Nine Mile Point Nuclear Station

License Renewal Application – Responses to NRC Requests for Additional Information Regarding Sections 2.2, 2.3.3, and 2.3.4 (TAC Nos. MC3272 and MC3273)

ATTACHMENT 1

Responses to NRC Requests for Additional Information (RAI) Regarding

Figure XI-4, Circulating Water System

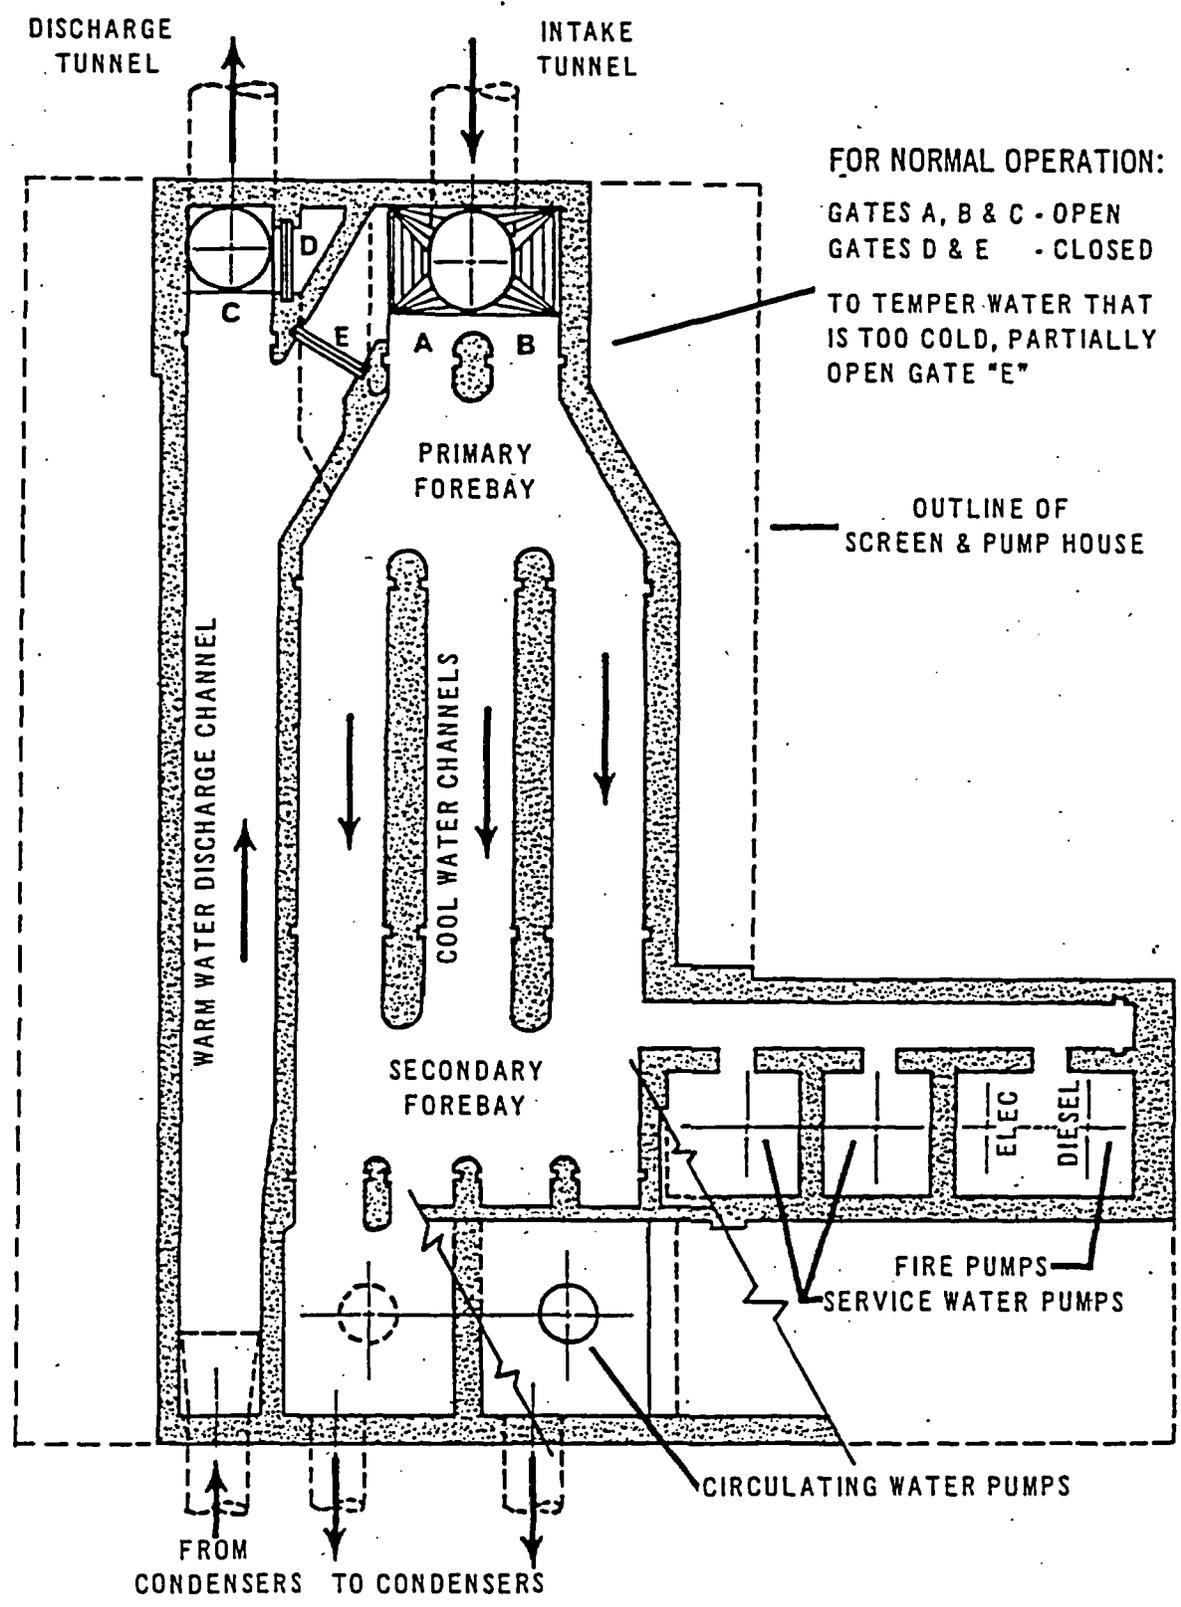
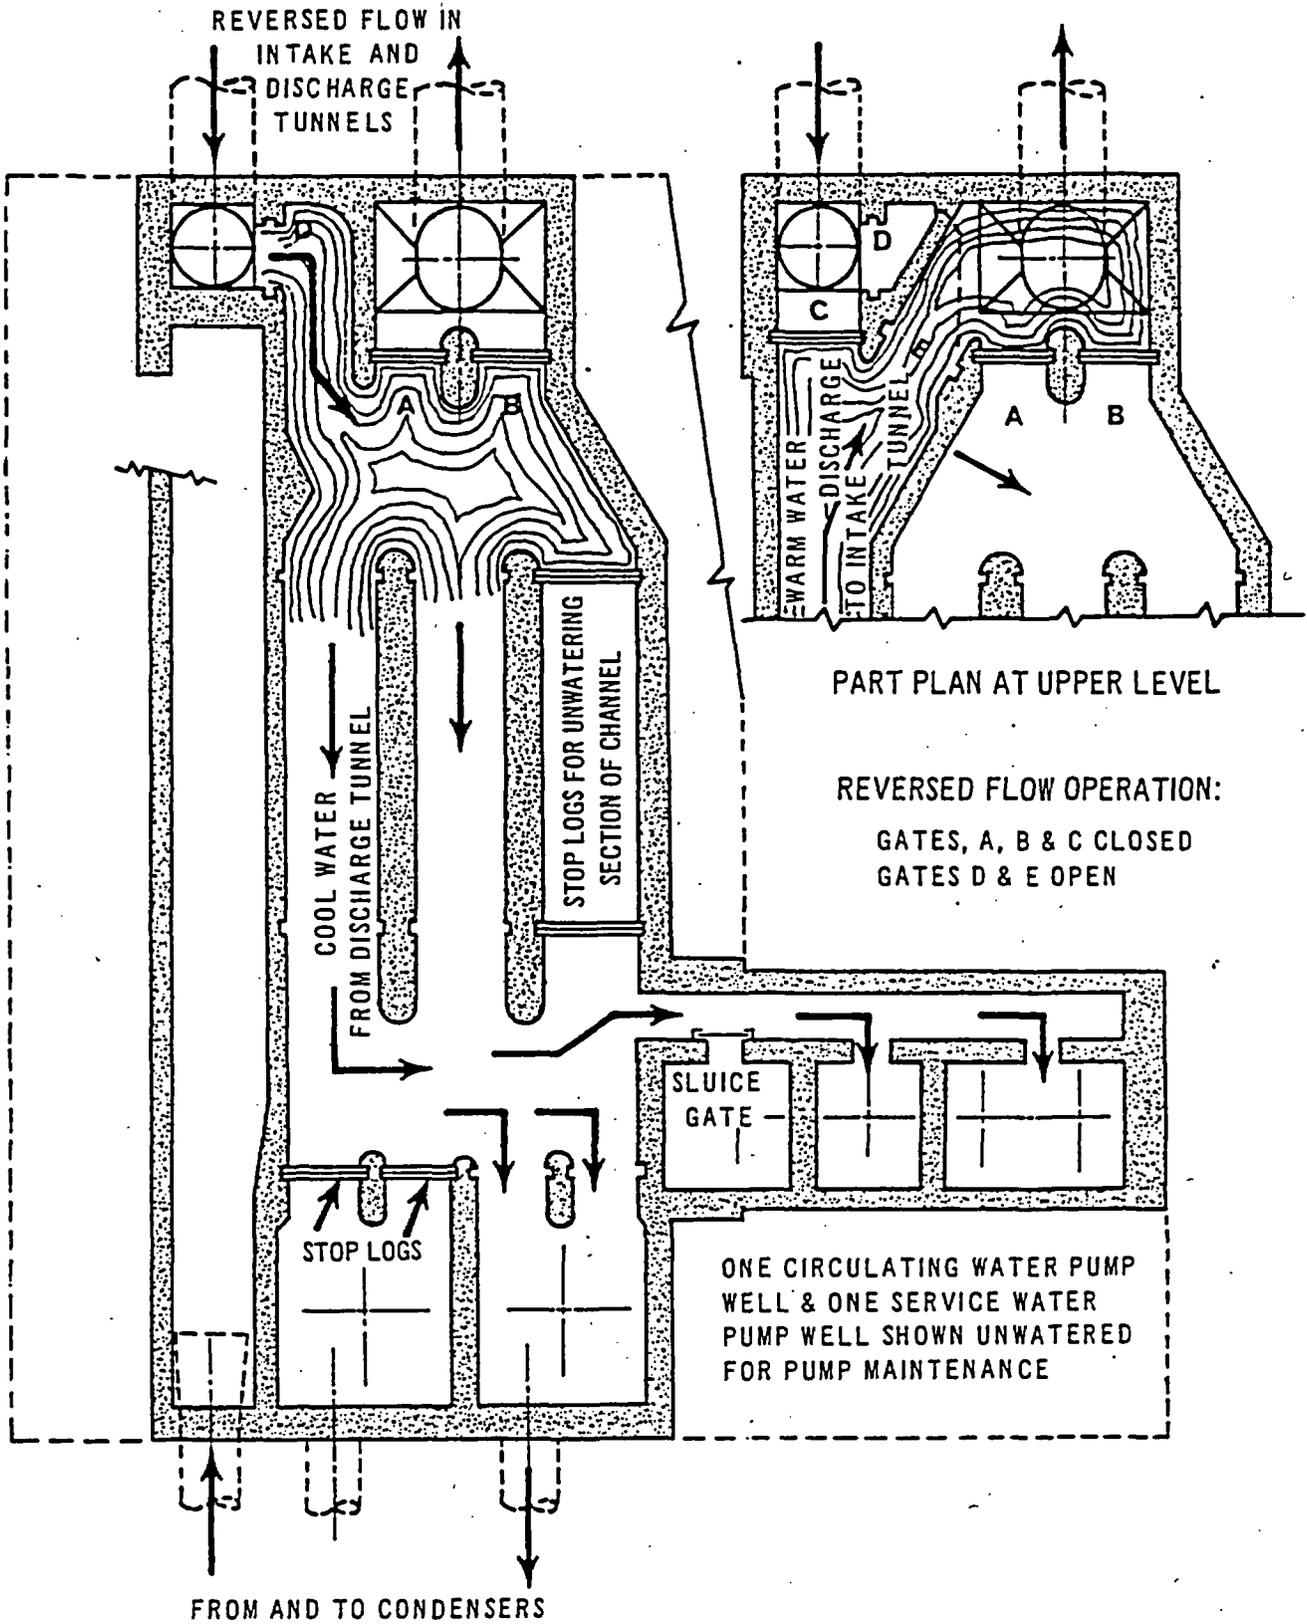
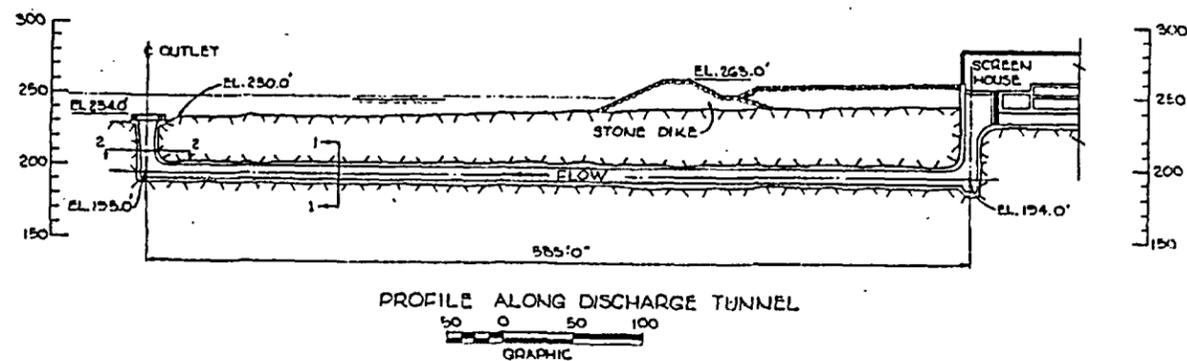
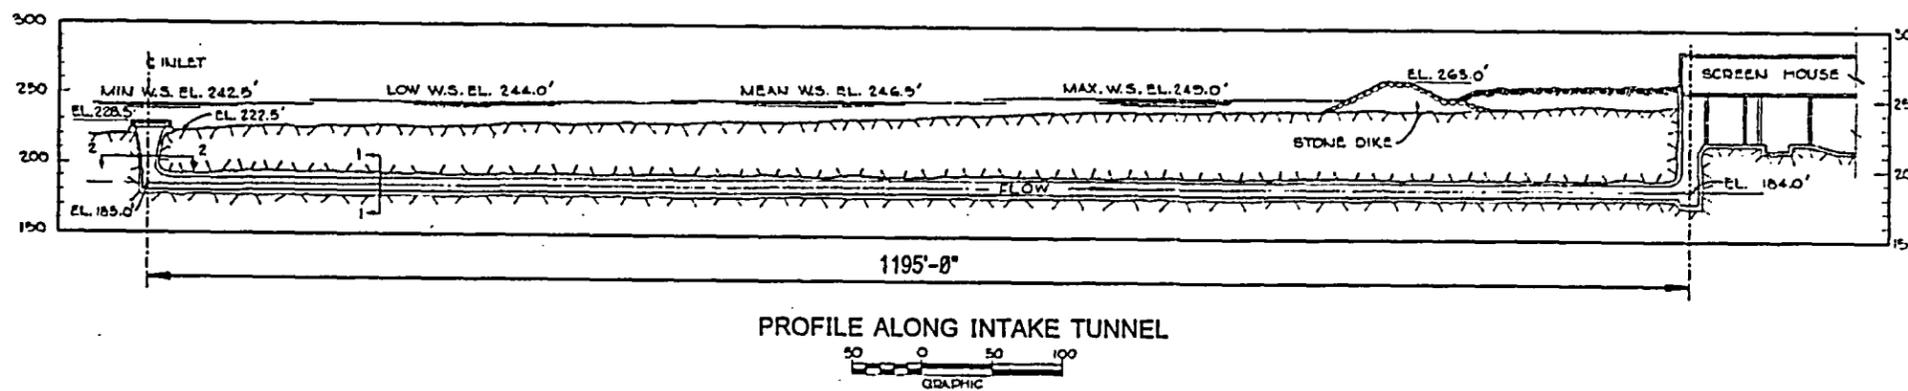
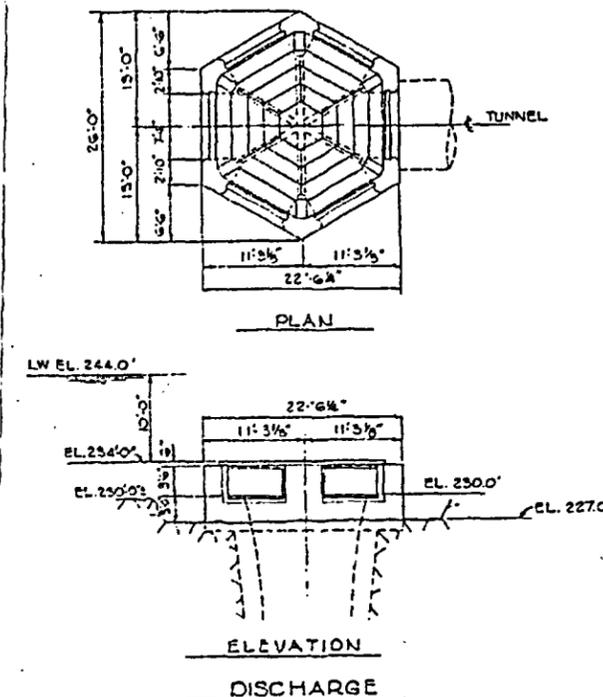
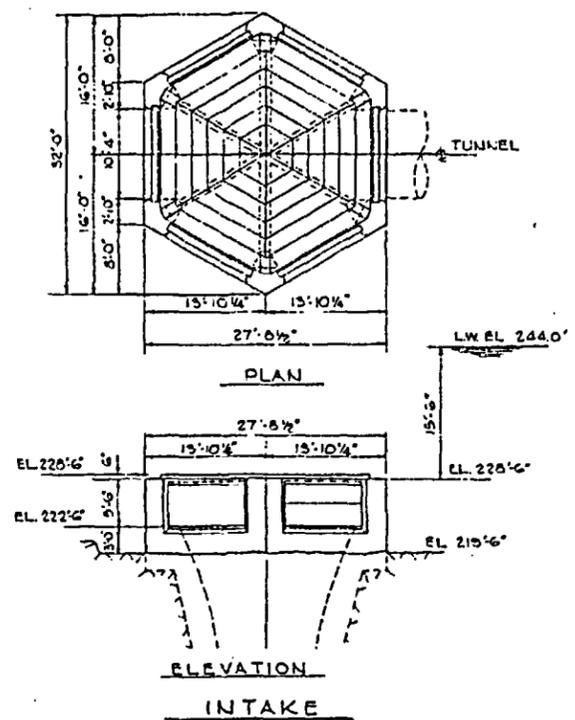
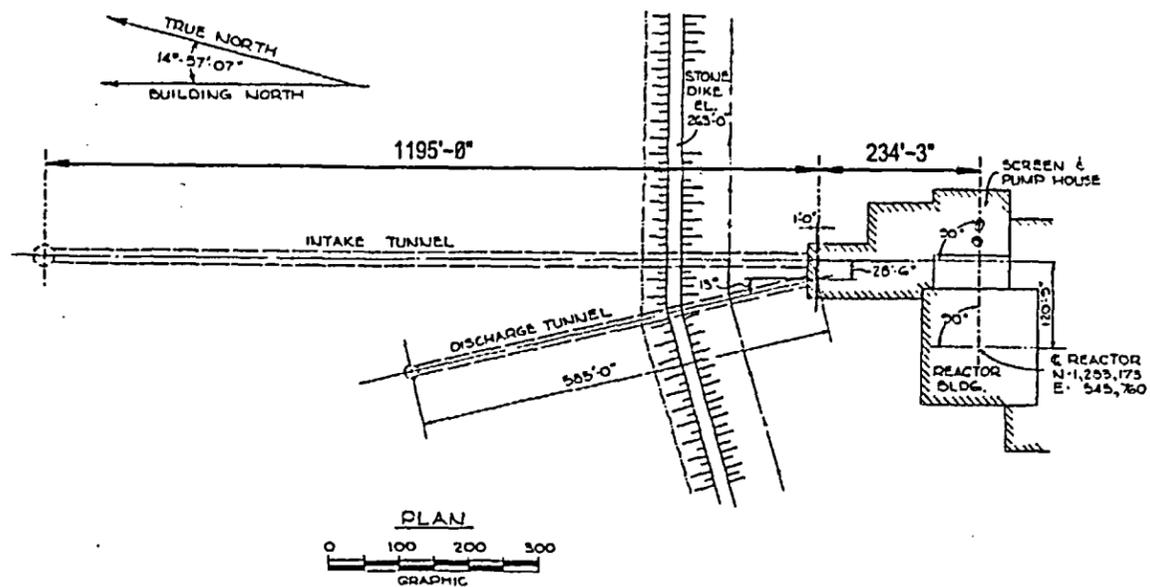
The circulating water system is shown on drawings LR-18022-C, sheet 1 and LR-26941-C. Because of the unique interface between the circulating water system, the emergency service water pumps, and the intake structure, the staff needs more information to complete its review to understand the configuration of the components requiring AMR. This information is not clearly depicted in the LR drawings. Supply the following figures from the NMP1 FSAR: XI-4, Circulating Water System; III-19, Circulating Water Channels under the Screen and Pump House - Normal Operation; III-20, Circulating Water Channels under the Screen and Pump House - Special Operations; and III-21, Intake and Discharge Tunnels Plan and Profile.
